BID ADDENDUM #2

Bid # RFB-2022-15

SUNY SCCC WELCOME CENTER

C2 DESIGN PROJECT #2006

3
A100 Detail at Data Room Wall and Soffit
SCALE: 1/2" = 1'-0"

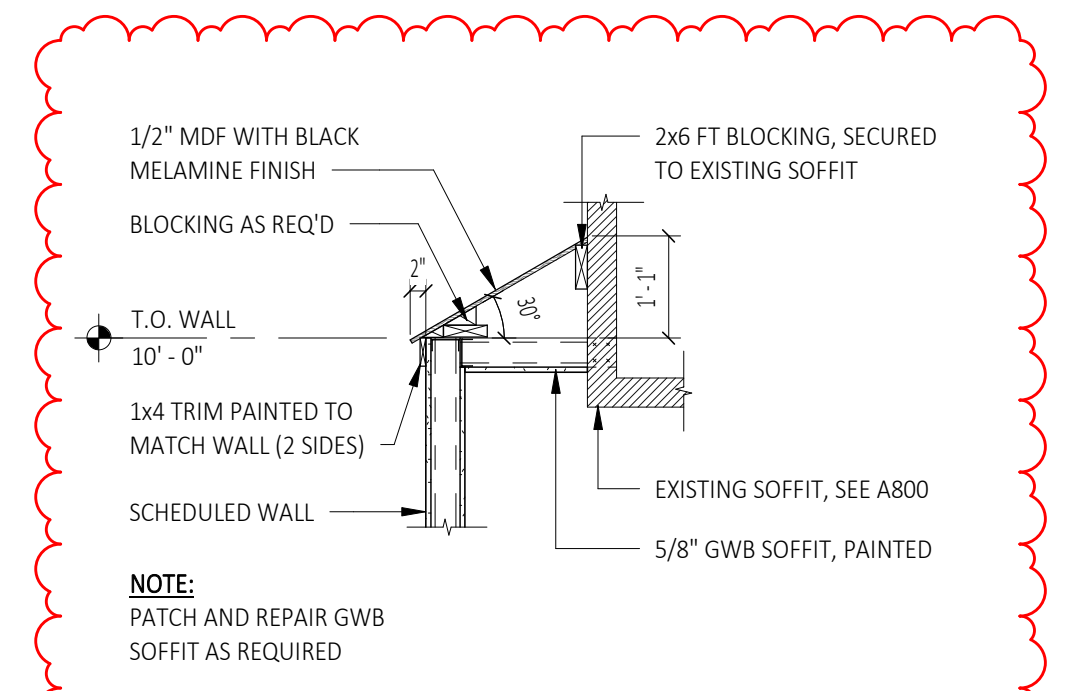
Drawing A100/Detail 3, Detail at Data Room Wall and Soffit:

- Detail 3:
 - New Partial wall section as noted.

1 Partial First Floor Reflected Ceiling Plan
A800 SCALE: 3/16" = 1'-0"

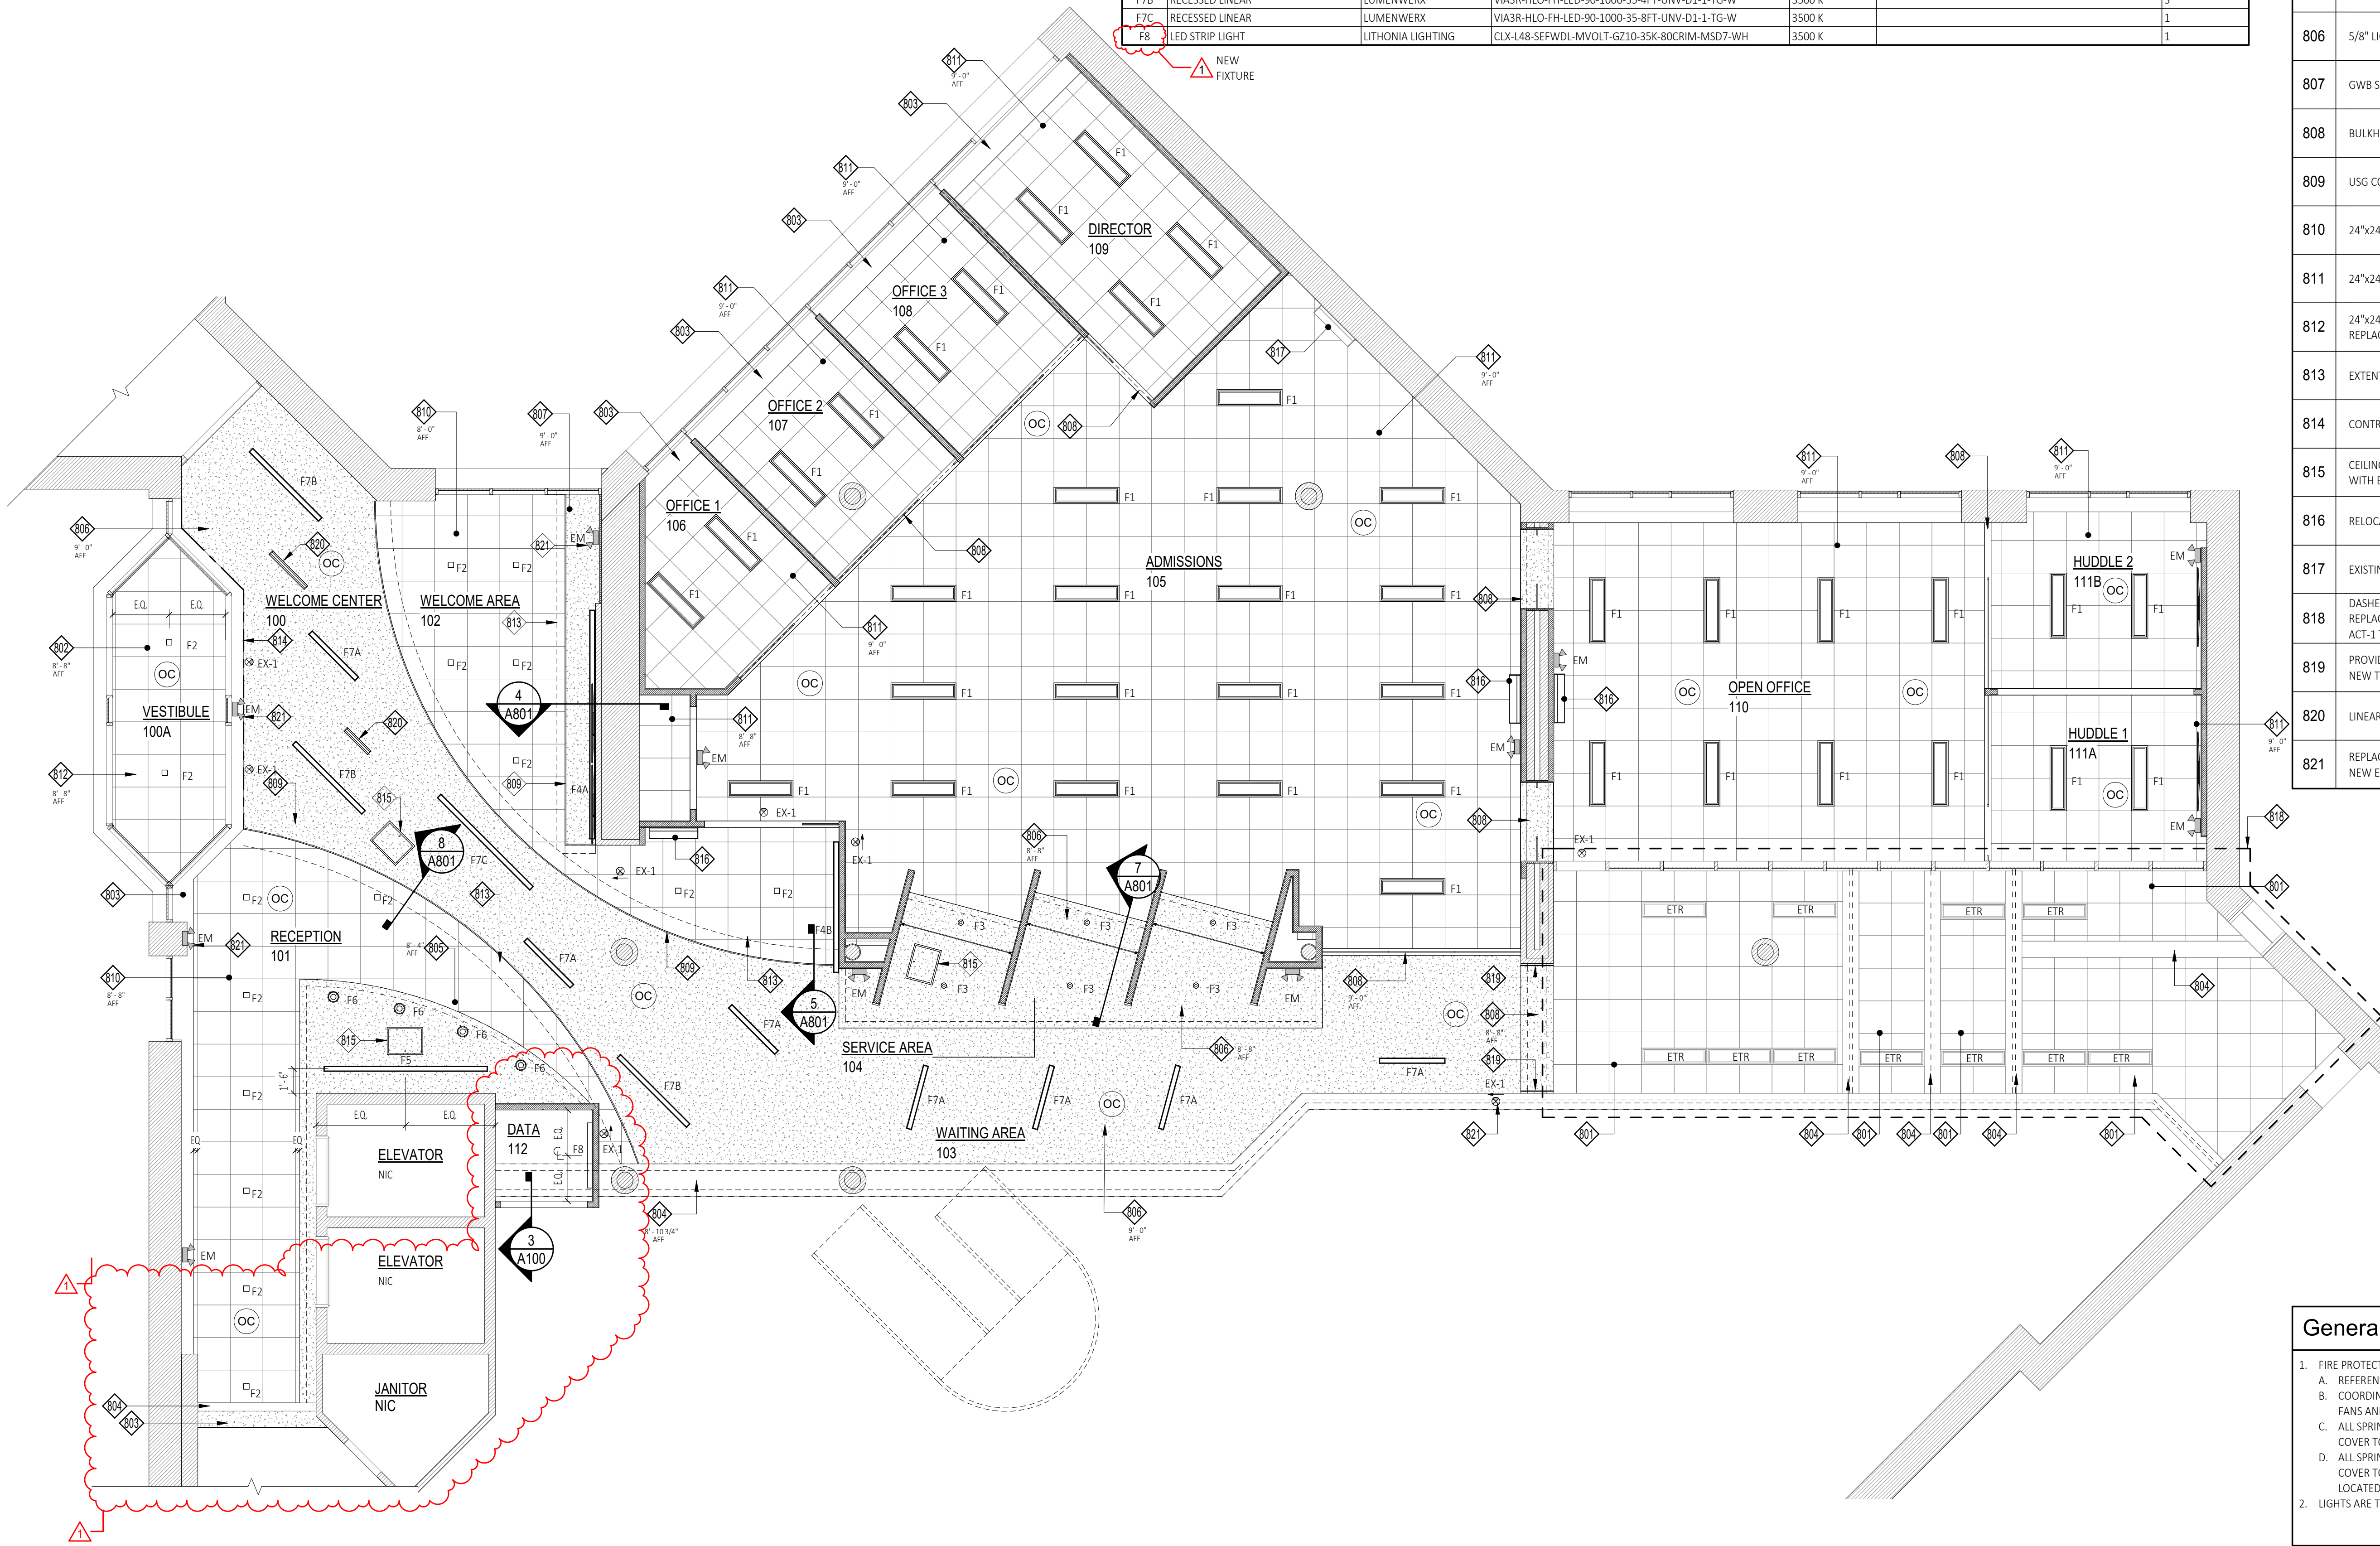
Drawing A800/Reflected Ceiling Plans:

- Detail 1, Partial First Floor Reflected Ceiling Plan:
 - Revisions as noted.
- Light Fixture Schedule:
 - Revisions type as noted.

1 Enlarged Reflected Ceiling Plan At Welcome Center (DIMENSIONAL)
A801 SCALE: 1/4" = 1'-0"

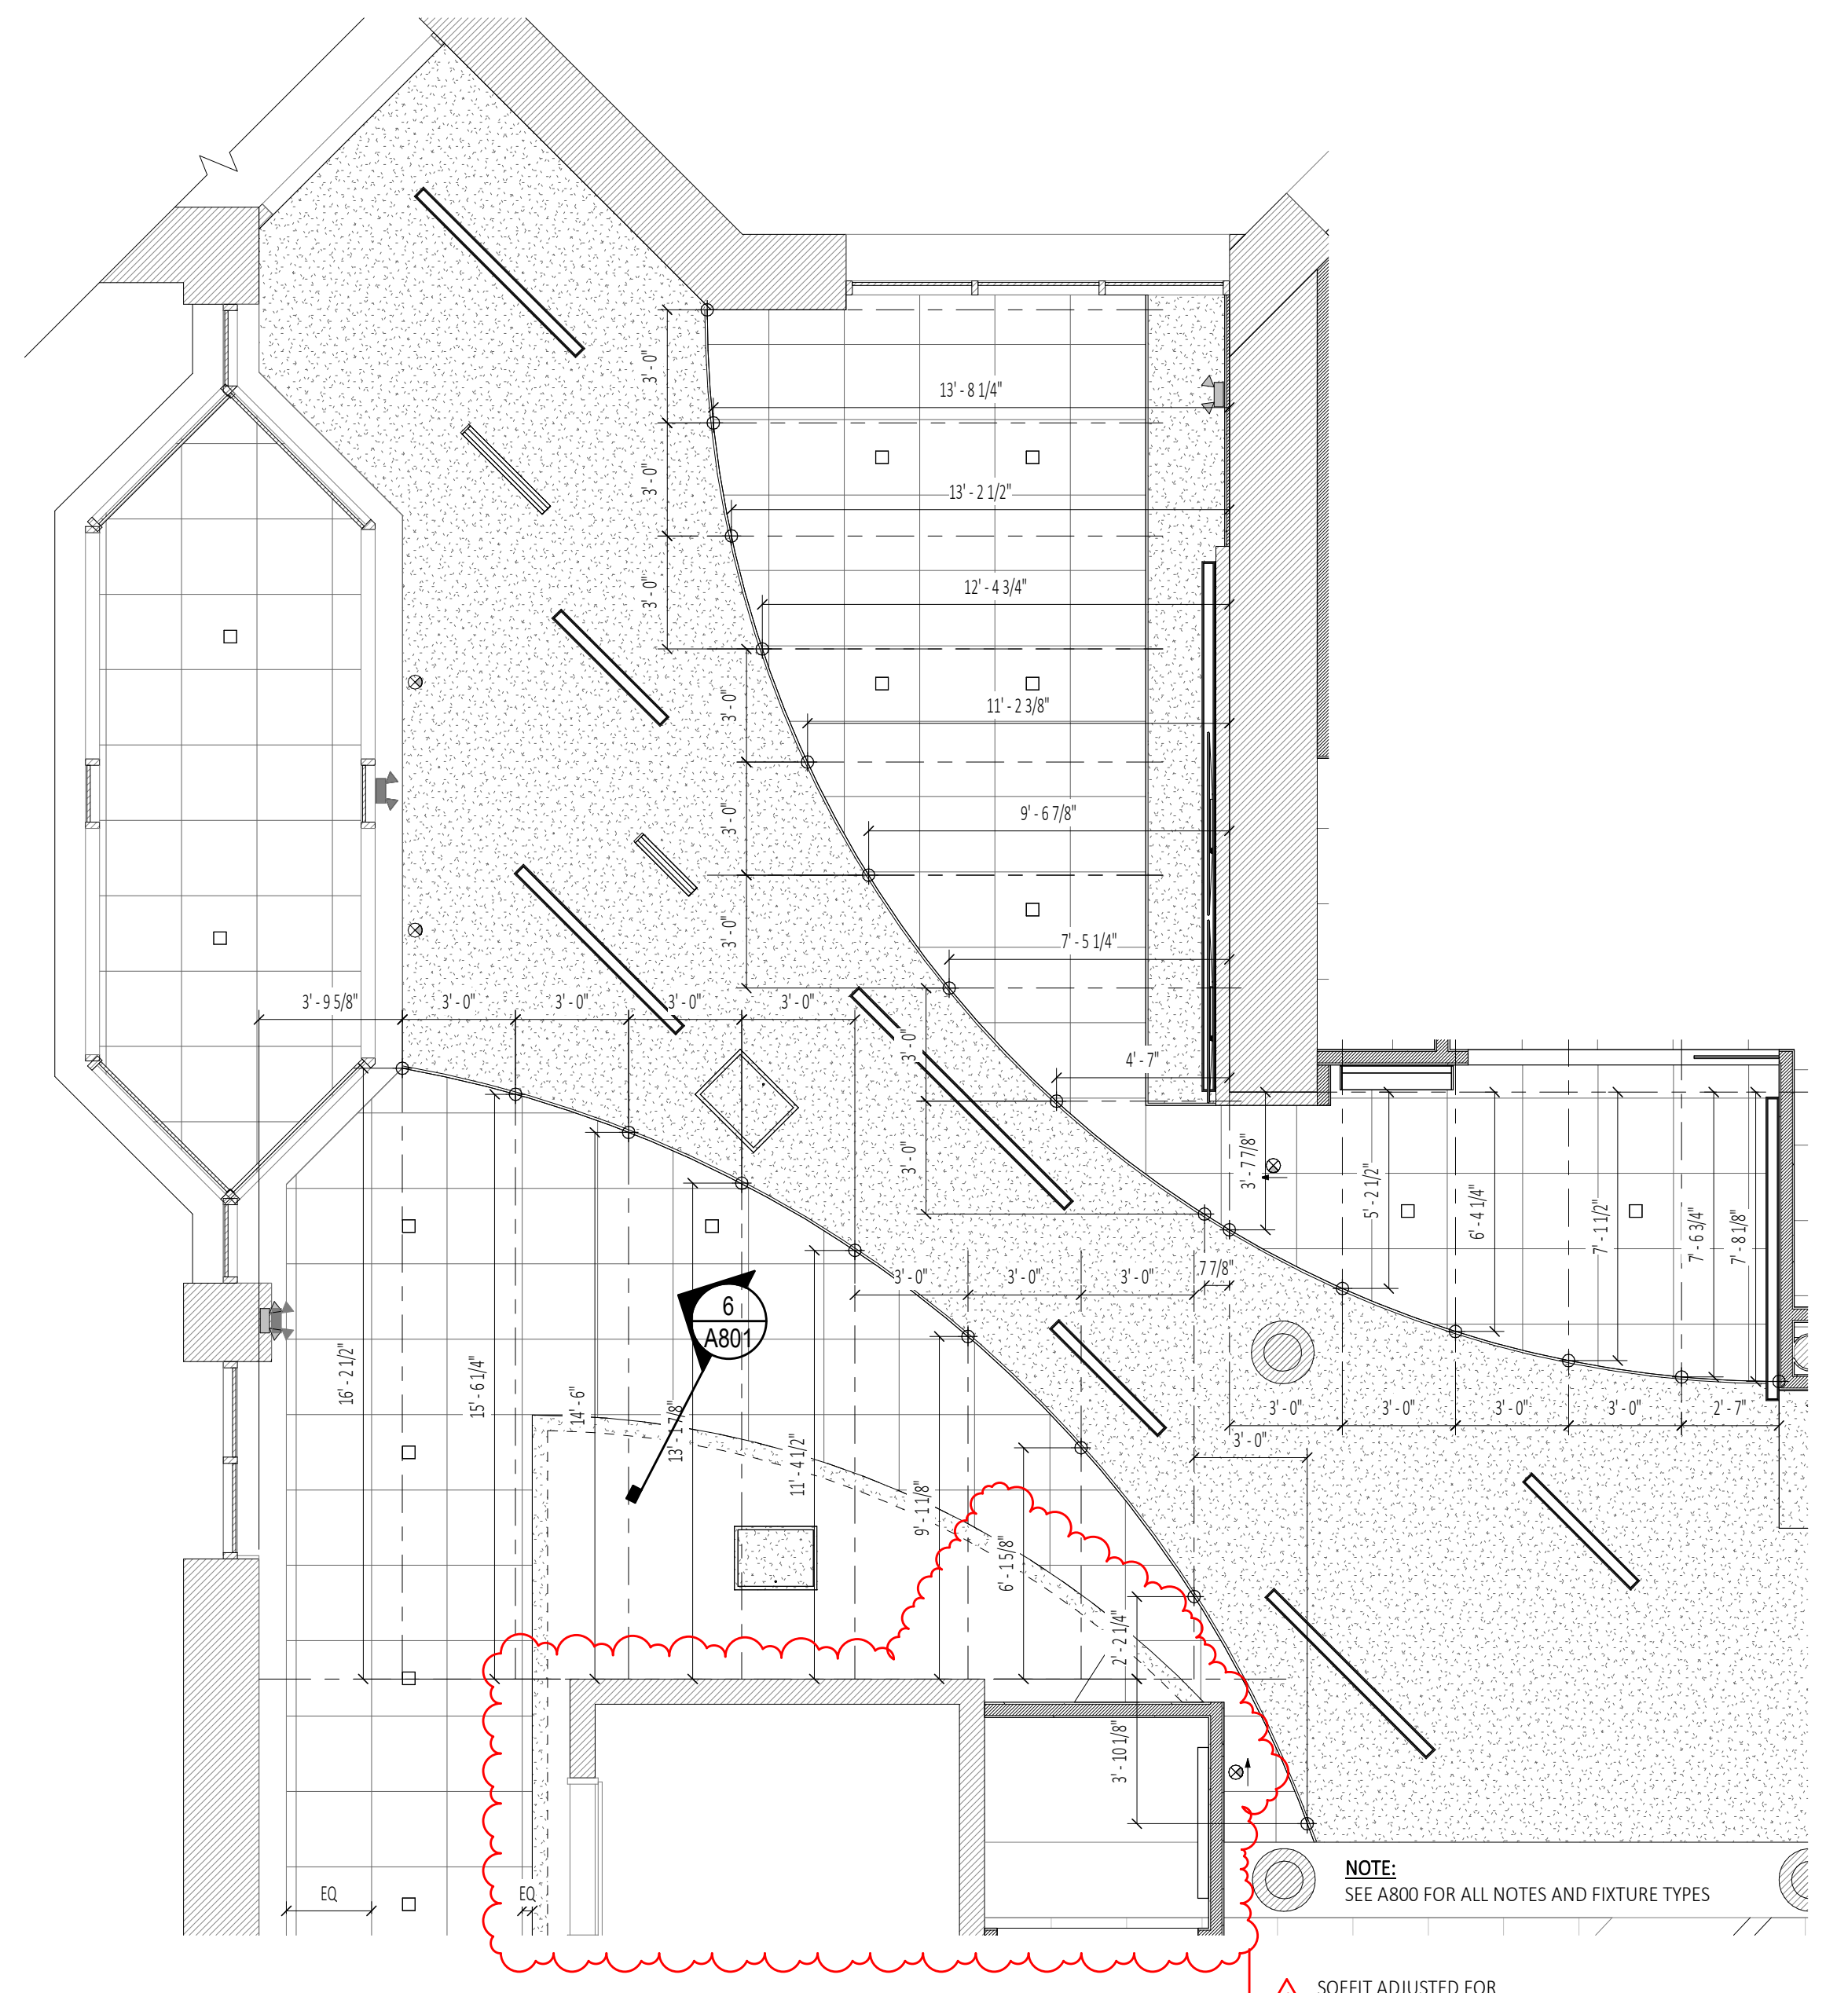
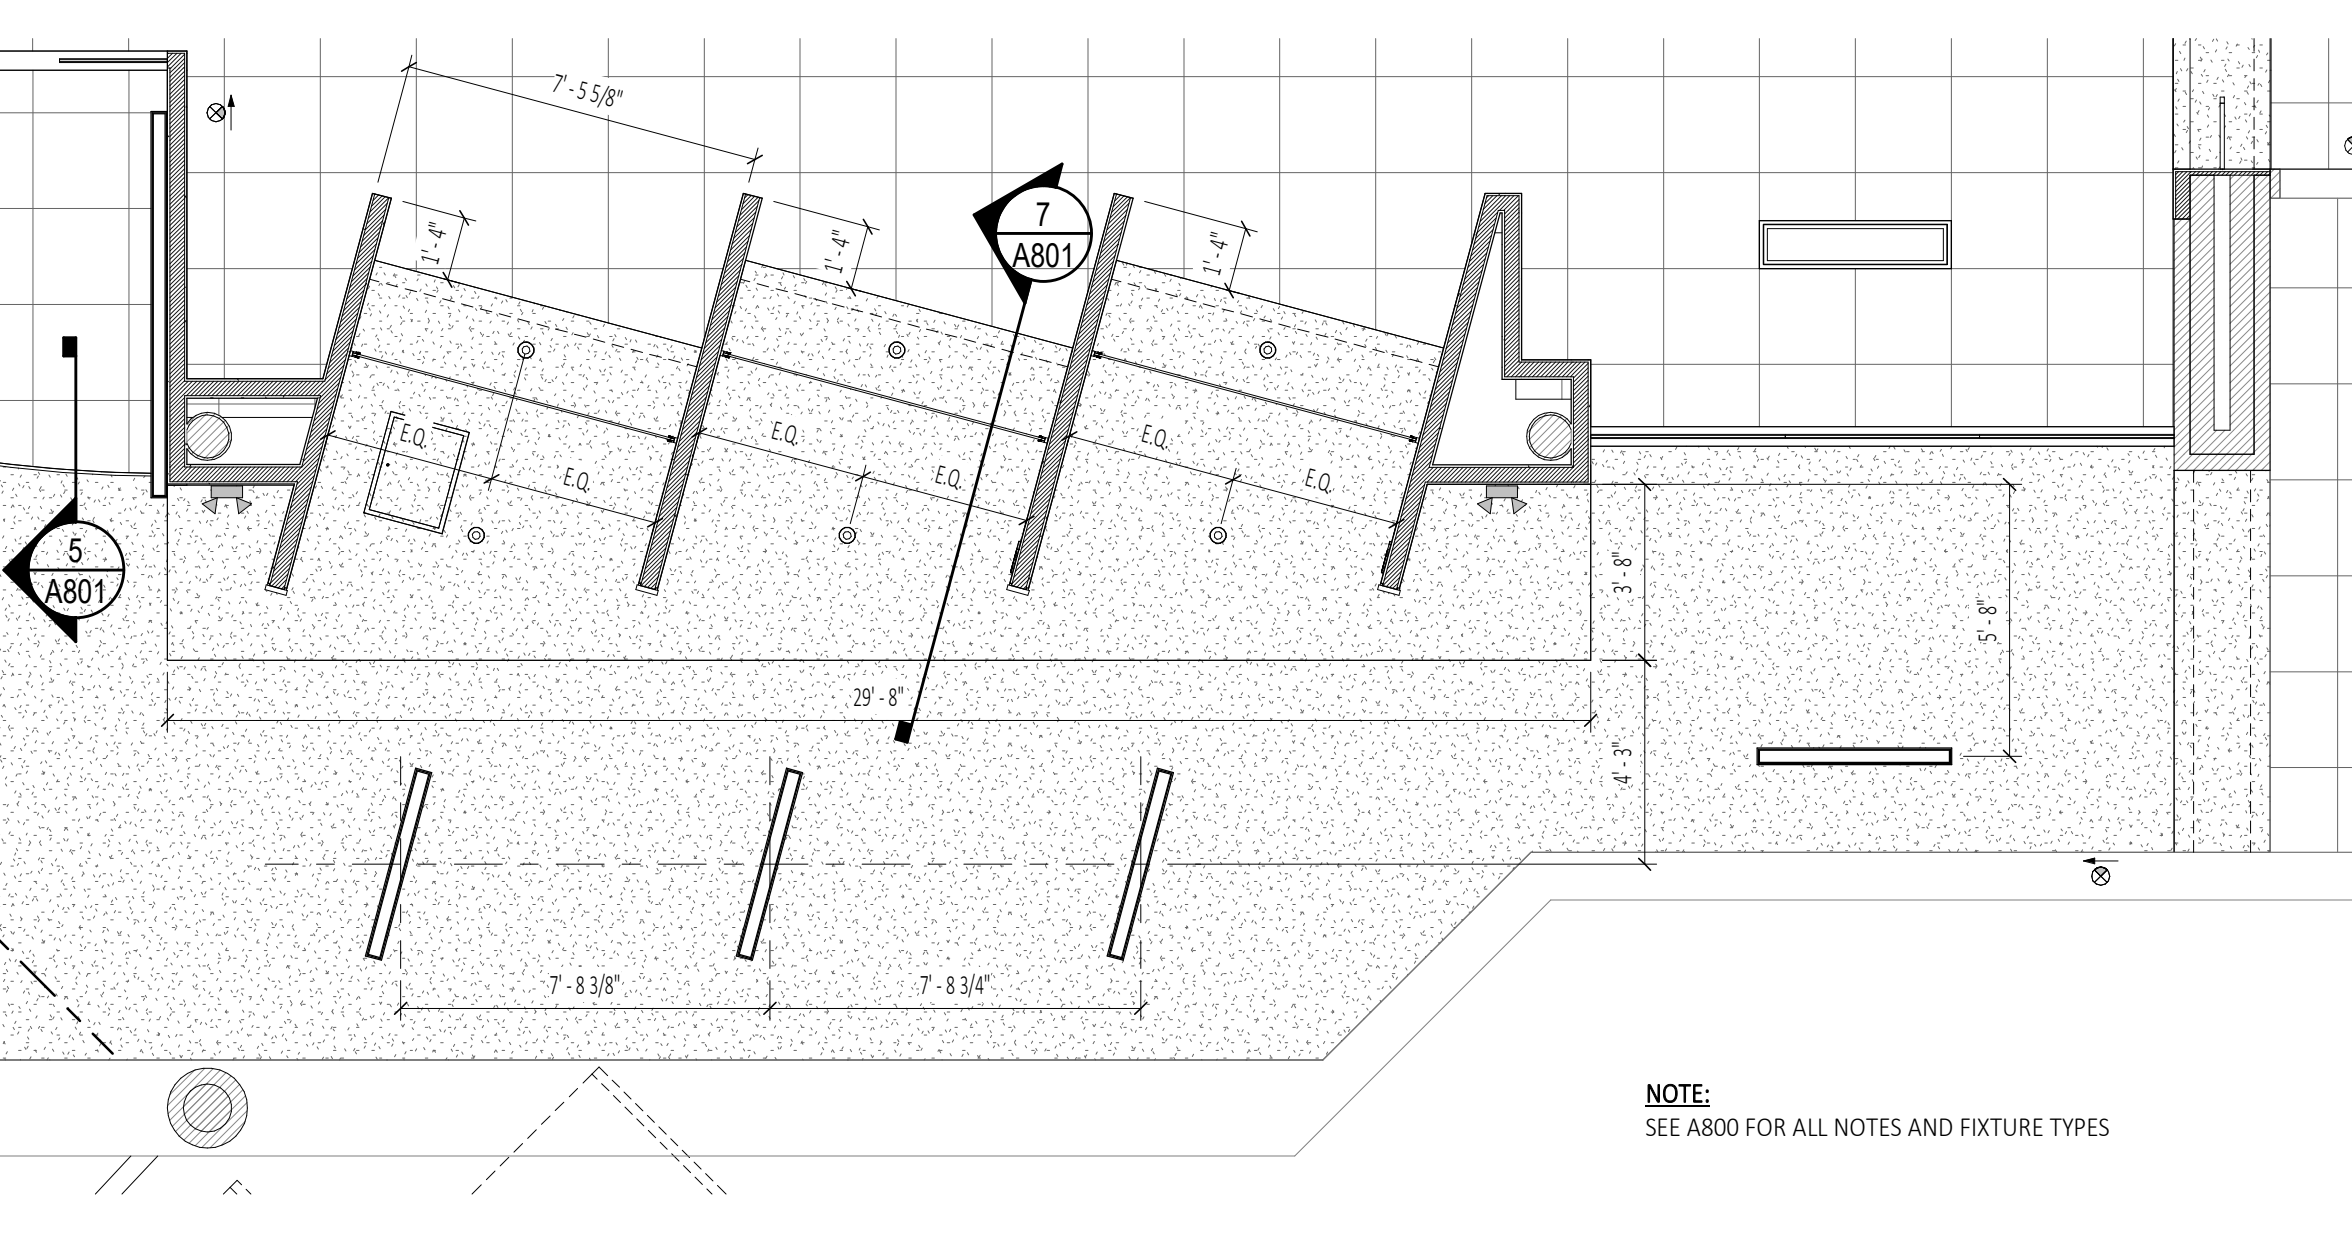
Drawing A801/Enlarged Reflected Ceiling Plan:

- Detail 1, 2, 3 Partial First Floor Reflected Ceiling Plans:
 - Revisions as noted.
